Work Plan

(From the BCRET first Quarterly Report October 1 to December 31, 2013

Automatic Water Sampler Upper End of the main fork of Big Creek.

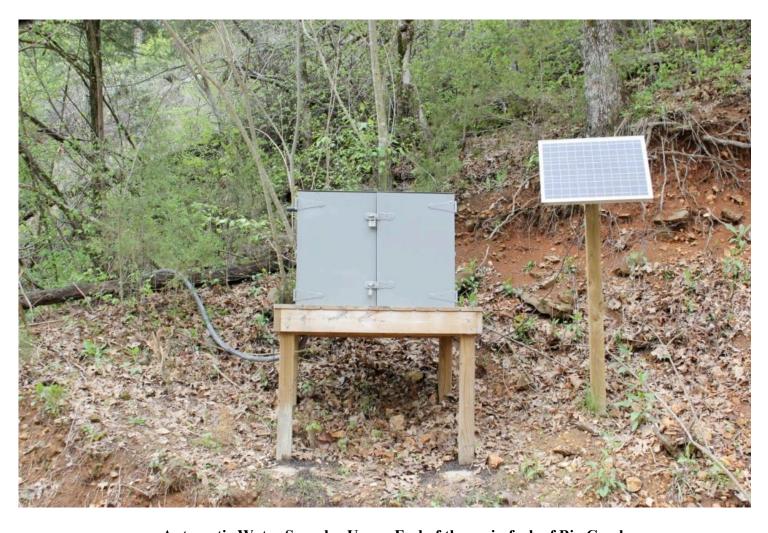
- This may be a repeated question but could you tell us when BCRET first started collecting samples?
- The auto sample site at the upper end of the main fork of Big Creek had been operational and then last winter the intake line was removed due to concerns of damage to the sampler by cold weather. Was the intake reconfigured at that time?
- Is the intake line suppose to be installed in a manner that will prevent an air lock or possible cross contamination of samples if more than one sample bottle is located in the collection base?
- Did USGS reinstall the intake line to the sampler at the upper end of Big Creek in the area south of the Valentines?
- Does this look like a proper installation of a water intake line for an automatic water sampler?
